Access Compliance Report

Public Rights-of-Way

Intersection ID: 16663	Main Street: BUCKNELL_AV	Cross Street: PRINCETON_AV	Location: SE
ADA ID: 67CAD100D11C	Ramp Type: PerpDiag	Initial Pass/Fail: Fail	Overall Compliance: No
Codes/Mitigation Info/Possible Solution			Severity Score: 25
			Field Measurements/Component Compliance

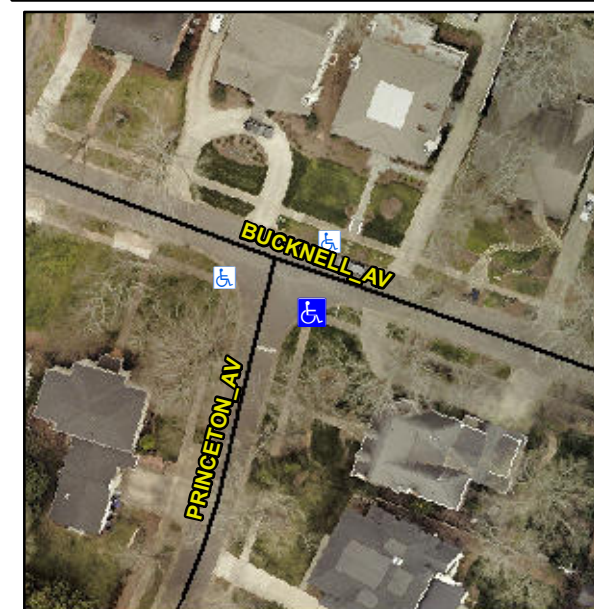
R304.2.2

Compliance	Description	Data	Compliance	Description	Data
N/A	Ramp Length (in)	43.0	No	Ramp Slope (%)	15.0
Yes	Ramp Width (in)	48.0	Yes	Ramp XSlope (%)	1.5
N/A	Flare Type LT	N/A	N/A	Flare Type RT	N/A
N/A	Flare Slope LT (%)	N/A	N/A	Flare Slope RT (%)	N/A
N/A	Flare Traversable LT?	N/A	N/A	Flare Traversable RT?	N/A
N/A	Landing Length (in)	N/A	N/A	DWS Provided?	N/A
N/A	Landing Width (in)	N/A	N/A	DWS Contrast?	N/A
N/A	Landing Slope (%)	N/A	N/A	DWS Length (in)	N/A
N/A	Landing X Slope (%)	N/A	N/A	DWS Full Width?	N/A
N/A	Landing Curb? (Y/N)	N/A	N/A	DWS Offset (in)	N/A
N/A	Shared Landing?	N/A			
N/A	Gutter Ponding?	N/A	N/A	Gutter Slope (%)	N/A
N/A	Gutter Lip Ht (in)	N/A	N/A	Gutter X Slope (%)	N/A
N/A	Painted X Walk1?	No	N/A	Painted X Walk2?	No
	X Walk 1 Direction	To NE		X Walk 2 Direction	To NW
N/A	X Walk 1 Width (in)	N/A	N/A	X Walk 2 Width (in)	N/A
	X Walk 1 Slope (%)	7.3		X Walk 2 Slope (%)	3.4
	X Walk 1 X Slope (%)	0.7		X Walk 2 X Slope (%)	5.5

Remove & Replace Curb Ramp With Two New Directional Ramps or Equivalent.
